Addendum 2
Solicitation 24-99842
Upper Lakeside Water Interconnect – Phase 1

ADDENDUM #2

Project Description City of Duluth
Upper Lakeside Zone Water Main Interconnect – Phase 1

3
6 **ROCK OVER BLAST FOR FUTURE SANITARY DETAIL**
FROM STA= 10+00.00 TO STA= 17+00.00

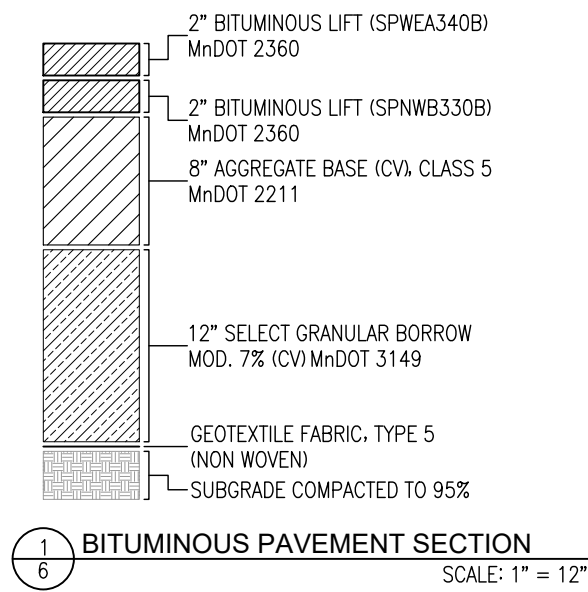
1. Sheet 2 SEQ: Addition of line items 15 and 24. Modifications to plan quantities and the construction notes.
2. Sheet 6 DETAILS: Added clarity to detail 3/6.

revision	11/27/24
REV 1	11/27/24
Proj:	24-525
Date:	11/13/24
Drawn:	DRH
Checked:	TTP
EXISTING CONDITIONS & REMOVALS	Sheet Title
Sheet Number	10

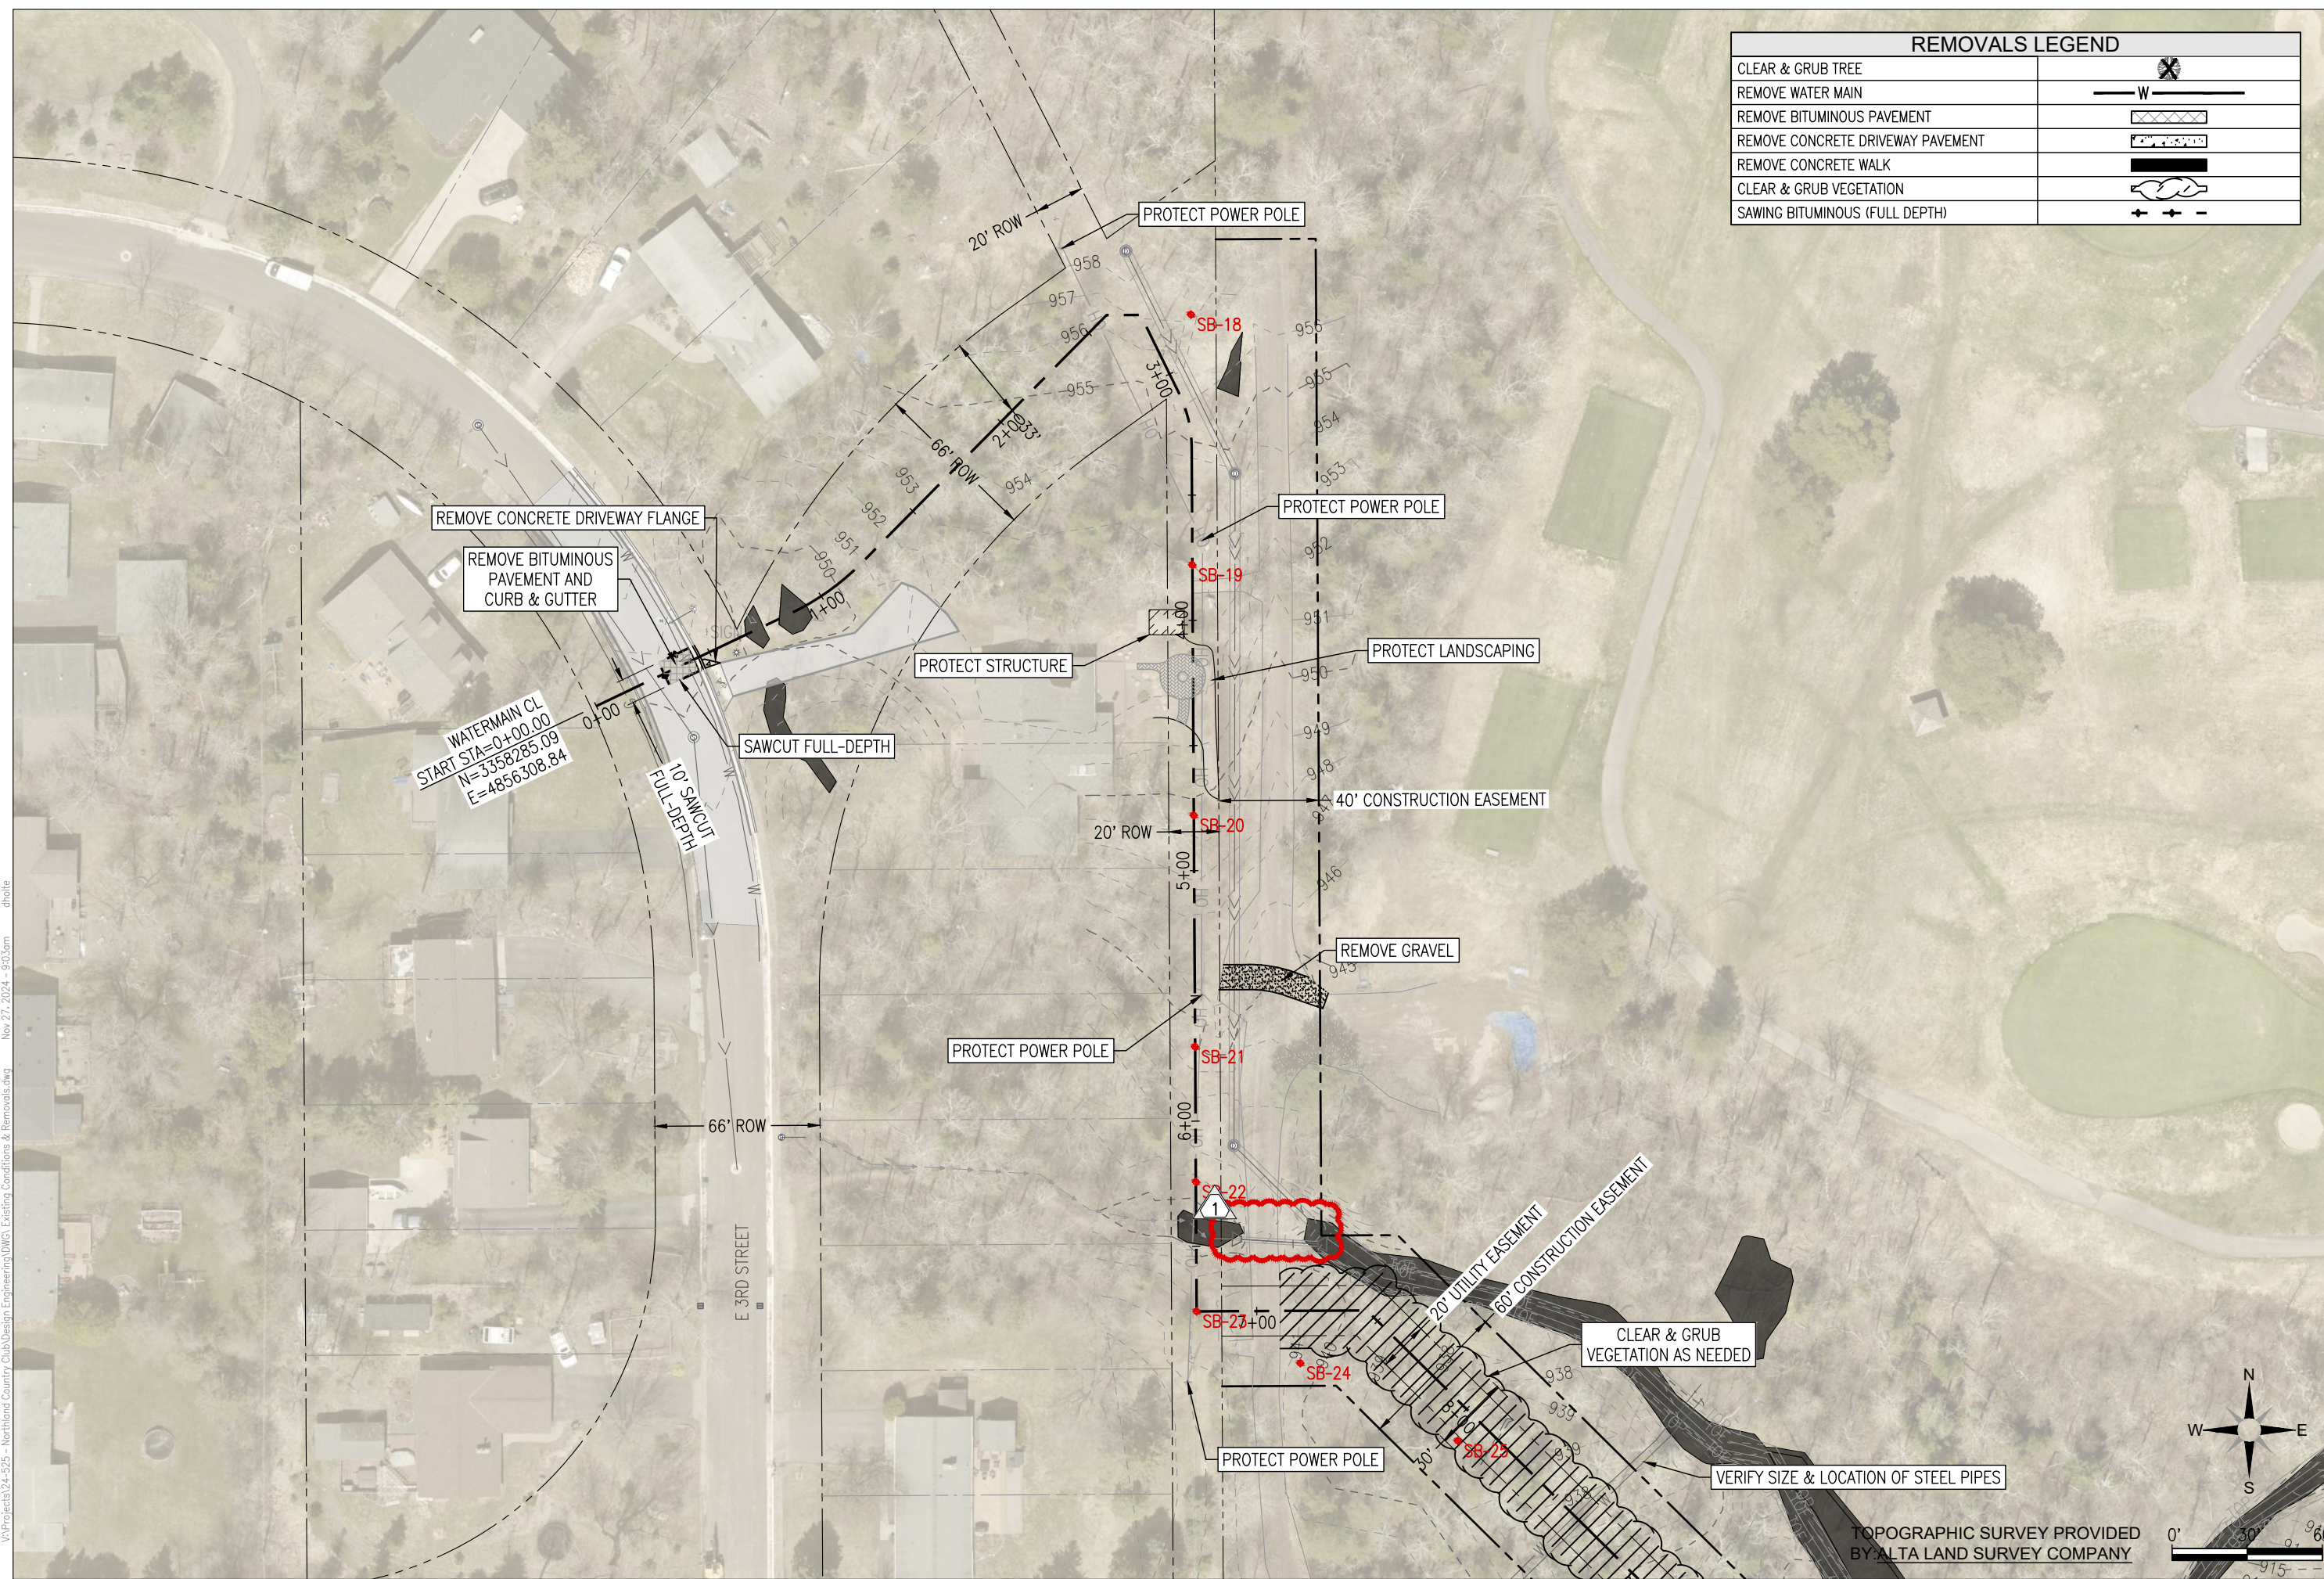
3. Sheet 10 EXISTING CONDITIONS AND REMOVALS: Existing pipe originally called out for removal will remain in place.
4. Sheet 14 PLAN AND PROFILE: Pipe EX-D-100 will not be replaced with new pipe.
